NOTICE TO BIDDERS
ADDENDUM #1
BOROUGH OF MADISON, MORRIS COUNTY, NEW JERSEY
HDM PLAZA RESTORATION
BID OPENING DATE – THURSDAY, DECEMBER 12, 2019, 11:00 AM

ADDENDUM #1 IS A MODIFICATION TO THE BID DOCUMENT ENTITLED HARTLEY DODGE MEMORIAL PLAZA RESTORATION AS FOLLOWS :

**HARTLEY DODGE MEMORIAL
PLAZA RESTORATION
50 KINGS ROAD
POLE BASE ADDENDUM**

**HARTLEY DODGE MEMORIAL
PLAZA RESTORATION
50 KINGS ROAD
SIDEWALK ADDENDUM**

LIGHT POLE BASE
NOT TO SCALE

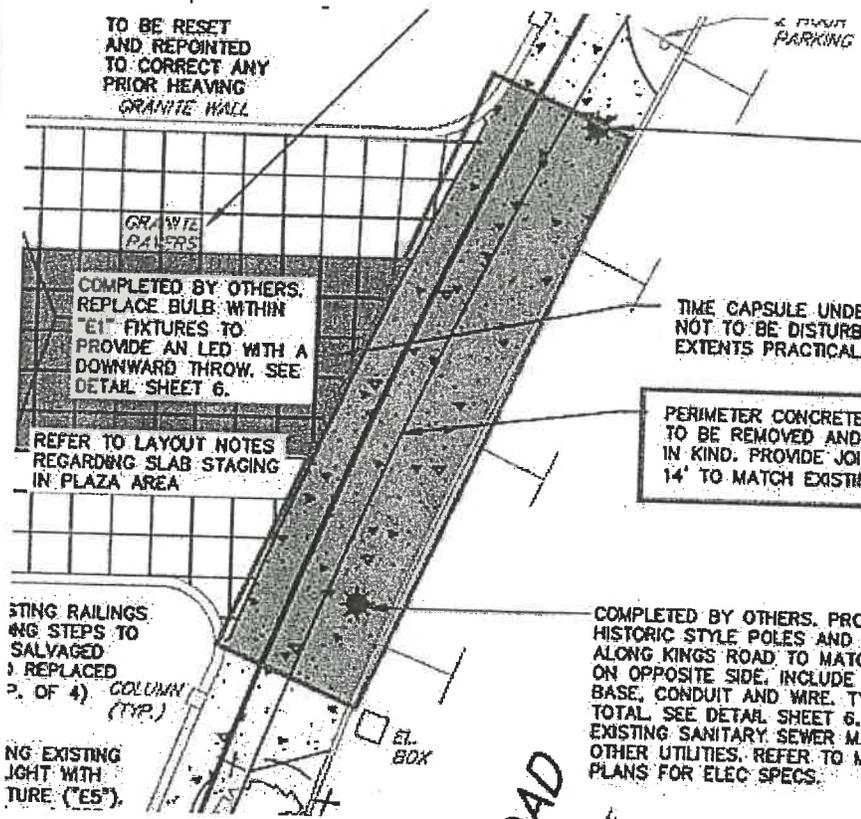
- 2) Drawing SP3 shows a new E1 type light fixture to be installed near the Northwest entry door at the ramp, and appears to be confirmed by drawing(s) A-100, F8/A-301 and A20/A-302. No existing light pole is apparent in the photos on SP6. Drawing SP3 also shows a new E1 type light fixture to be installed near the Northeast entry door and appears to be confirmed by drawing(s) A-100 and A8/A-301. No existing light pole is apparent in the photos on SP6. Drawing E0.00 does not show any electrical conduit/feeder routing called out for either of these lights and no clarification on the pole base is provided for these specific lights. Please confirm that replica two replica type E1 light fixtures (type E1) are required as shown on A-100 and if so, please provide clarification on the electrical drawings for panel location and conduit routing. Please also confirm the pole base detail for these fixtures if required?

Response: New pole and fixture to match existing ones. The existing E1 lights are mounted on top of the site wall, so the bases of the poles are a few feet off the ground. The new poles will be installed in the lawn, so the pole will need to

be higher than the existing ones so that all top of fixtures align. See attached drawing 01-Pole Base Addendum.
